CITY COUNCIL REGULAR MEETING AGENDA

Wednesday, August 28, 2024 at 6:00 PM

A. **SUBJECT:** Public Hearing Regarding General Plan Amendment 2023-01, Mitigated Negative Declaration 2023-01, Rezone 2023-01, Tentative Subdivision Map 2023-01, and Annexation 2023-01 pertaining to the Whispering Falls Residential Development Located on the East Side of South Modoc Avenue Between West California Avenue (Proposed) and the West California Avenue Alignment/San Joaquin Valley Railroad (APNs 020-160-36S, 020-160-18S, 020-160-19S, 020-041-45S, 020-041-47S, and 020-041-09U) (BC)

WHISPERING FALLS
PLANNED DEVELOPMENT AND TENTATIVE TRACT MAP IN CITY OF KERMAN/FRESNO COUNTY

PHASE I SITE PLAN
C3.1

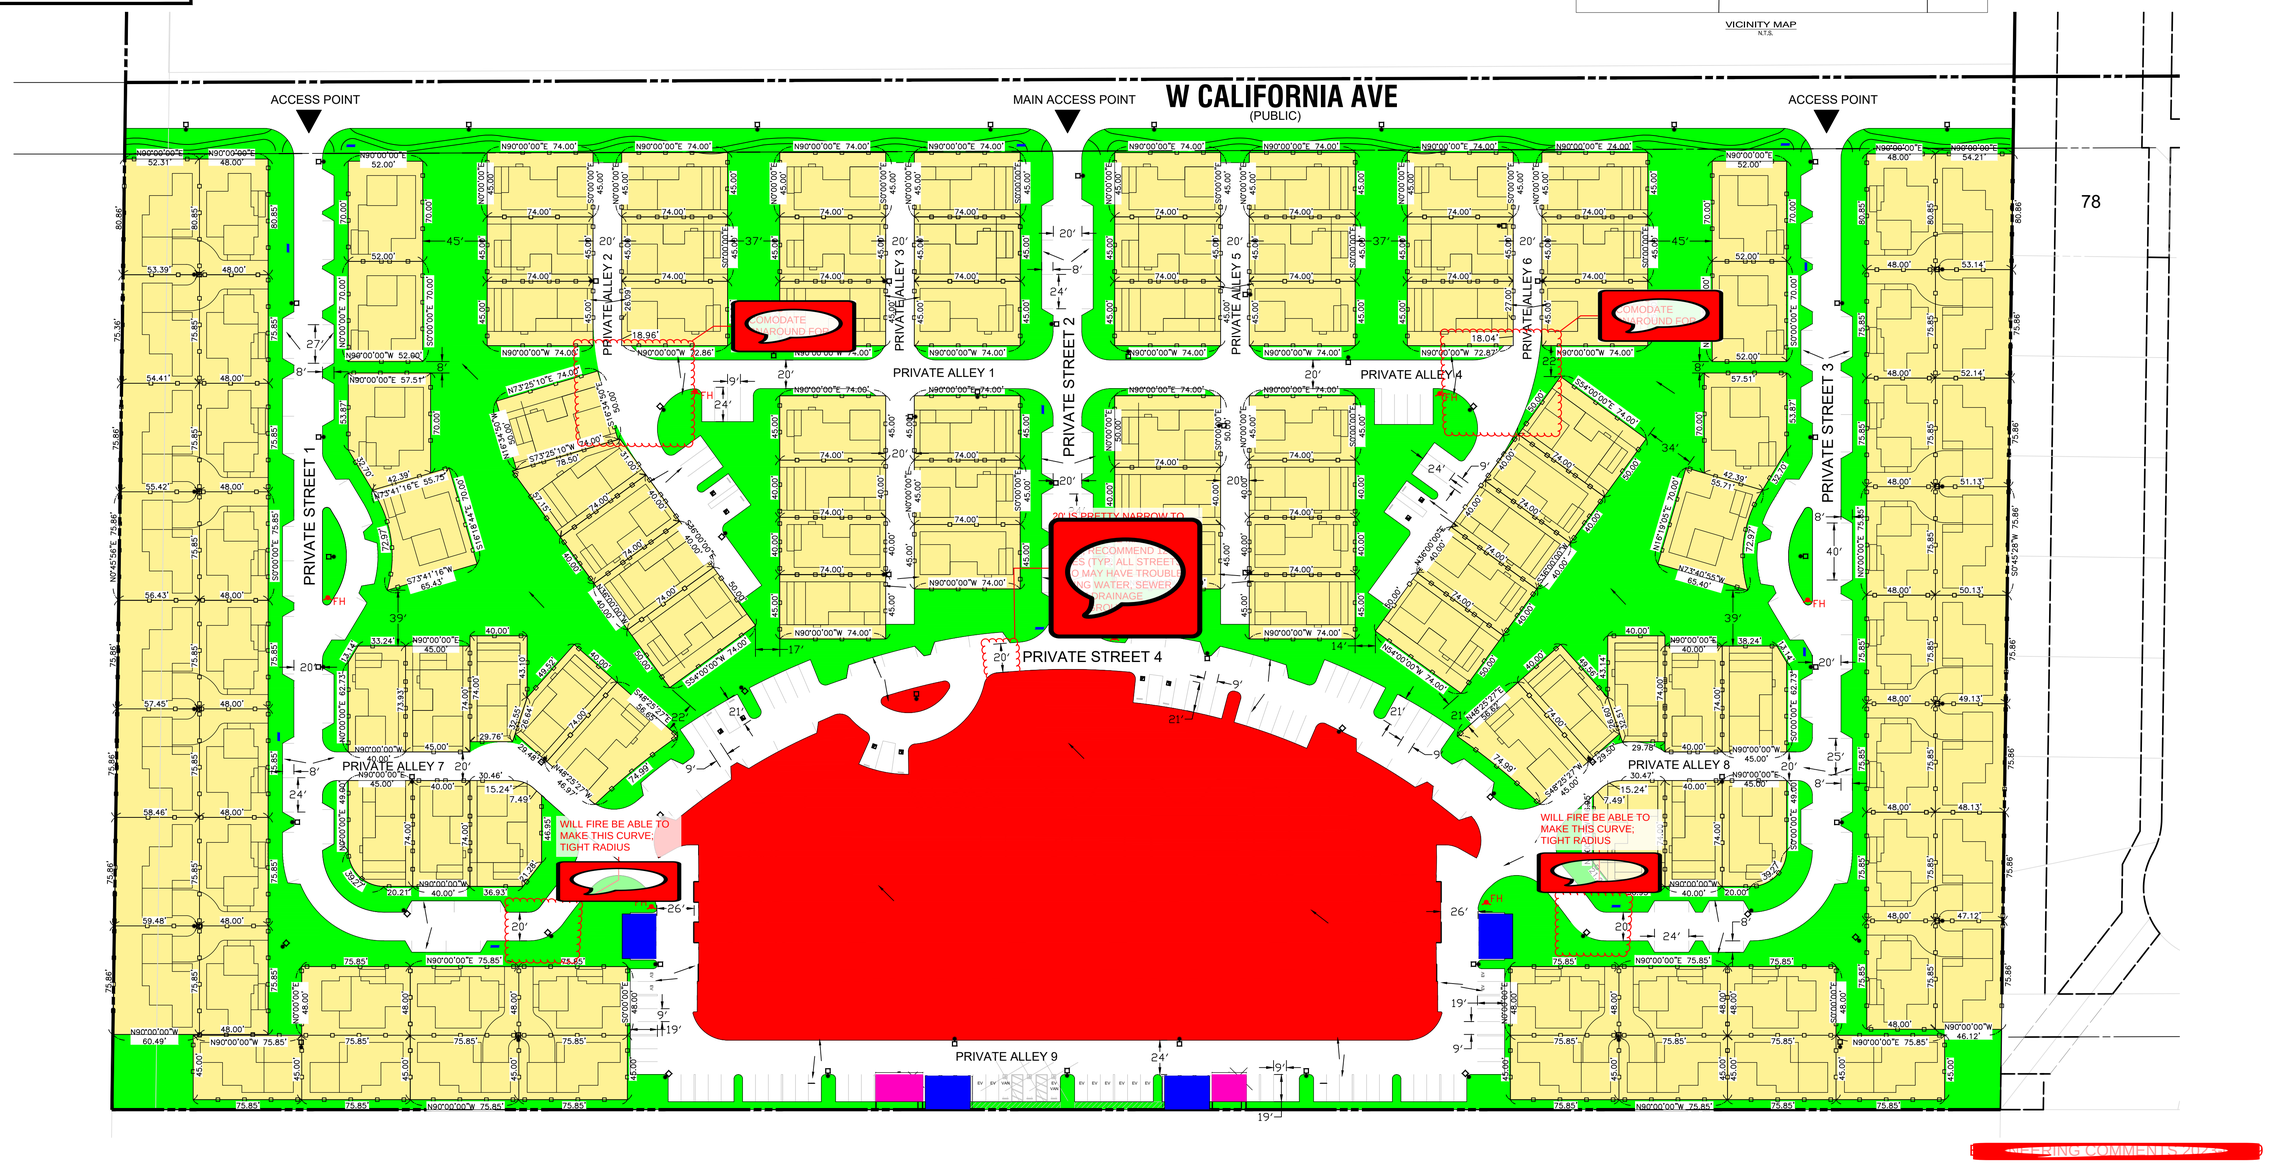
ENGINEERING COMMENTS 2022

Revisions required. Revise site plan (C3.1), tentative map (C4.0), preliminary grading plan (C5.0), and preliminary utility plan (C6.0) in accordance with **Exhibit A** dated May 10, 2023. Transfer all redline notes and comments to the corrected exhibit(s) and submit them to the Community Development Department. Revisions are summarized as follows.

2. Please note that sheet C2.0 does not match sheet C3.1 in regards to the alley width to the south of the Apartment buildings. Sheet C3.1 shows the required minimum width of 26-feet.

4. Per California Fire Code, Section D103.1 – where a fire hydrant is located on a fire apparatus access road, the minimum road width shall be 26-feet exclusive of shoulders. There are currently several sections of roadway on sheet C3.1 and Sheet C6.0 that DO NOT meet this requirement.

Response: Revised the inside turning radius to 34' at the two areas indicated on the redlines. Also provided hammerhead turnarounds at the west and east end of the alleys in accordance with the Fire Department Access Policy. See Truck Turnaround Detail added to Sheet C3.1.

Response: Plan sheets have been updated in accordance with Exhibit C as required. Please see calculation added to Sheet C3.1 showing the ratio of open space to residents. The lot diagrams on Sheet C2.2 have been updated to show usable open space, and that it exceeds 250 SF for each lot. The tables on Sheet C2.2 have been updated to show lot coverage and provided rear yard setback as appropriate.
